Repair Detail K
Renovation of shaft capping plates | Not to scale

REVISED PROPOSAL – HEADFRAME 2

Drawn	Designed	Approved	Revision Date
A Swan	A Swan		12/08/2019
Project No.	Scale		
V-C8458.60	As noted		
Project			
Cefn Coed Colliery Museum Renovation of two Grade II* Listed headgear frames			
Sheet			
Repair details K + L Various detail, to be read in conjunction with Repair Schedule documents			
Drawing No.	Sheet No.	Revision	
CD-V-C8458.60	104	R1

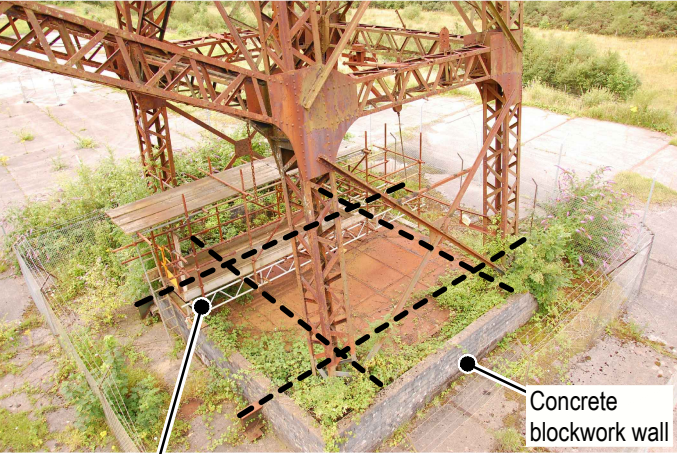
Elevated view showing typical condition of Headframe 1 shaft capping plates. Steel framing below of similar arrangement to that denoted on Headframe 2 (right).

HEADFRAME 1:
Accumulation of debris over plates to be removed. Fallen metalwork from within ventilation shaft to be retrieved for inspection.

Elevated view showing typical condition of Headframe 2 shaft capping plates. Steel framing below denoted by dashed lines.

HEADFRAME 2:
Safety and robustness of scaffold platform cannot be confirmed; platform to be dismantled and removed to accommodate anticipated working platforms erected by the Contractor.

BOTH HEADFRAMES:
It is understood that the existing shaft capping sheets were installed circa 1975; their condition is unknown.

ORIGINAL PROPOSAL
The Contractor was to allow for investigation to determine condition of the existing capping sheets, by removing a selection of sheets. Results of the investigation was to inform final repair works, for approval by the Local Planning Authority. It was assumed that the entire shaft capping structure could be replaced on a like for like basis (but in galvanised steel) if repair was not possible.

Following closer visual inspection, it appears the sheets have been welded to the grid of steel beams supporting them, making their removal for investigation of the structure below difficult without 'hot works' (grinding or flame cutting) and the hazards that presents over historic mine workings (risk of explosions). Furthermore, investigation work or partial dismantling of the existing structure may disturb the upper extents of the mine shaft opening with potentially significant consequences.

1. A new access platform will be constructed over the existing capping structure.
2. In the first instance, the new access platform will allow the renovation works to take be undertaken safely, requiring the following elements of work:
 - a. Clearance of vegetation and debris and removal of the existing scaffold walkway;
 - b. Partial dismantling of the concrete blockwork wall to the eastern side of the shaft (which conflicts with new platform footprint);
 - c. The new structure takes support off the visible ends of the existing steel support beams, which are of sufficient cross-section to support the additional loading;
 - d. The original structure will be cleaned to receive an application of protective paint, accessed by removing individual open-grid deck panels of the new structure.

The new structure will be bolted to the top flange of the original beams, requiring four holes to be drilled into each beam-end to allow insertion of connecting bolts.

3. Upon completion of the renovation works, the new structure could be removed:
 - a. the dismantled section of blockwork wall would be rebuilt – we note the wall shows signs of movement and will require more extensive rebuilding.

4. However, retention of the structure will offer further benefits:
 - a. The platform will provide a safe means of access for future maintenance and inspection of the structure;
 - b. The platform could also be used by museum visitors to view the structure (subject to other separate access provisions by the museum);

5. The following works are therefore proposed to realise these benefits:
 - a. The concrete blockwork wall is removed around the full perimeter (in lieu of rebuilding) to expose the original brick plinths that are largely obscured from view by the wall; the plinths will be subject to masonry conservation work in line with that already agreed by the LPA.
 - b. The new platform is retained permanently.

The platform will be of unpainted galvanised steel construction to clearly identify it as a modern addition (the historic structure will all be painted). It can be dismantled and removed in the future, if required, with negligible impact on historic fabric.
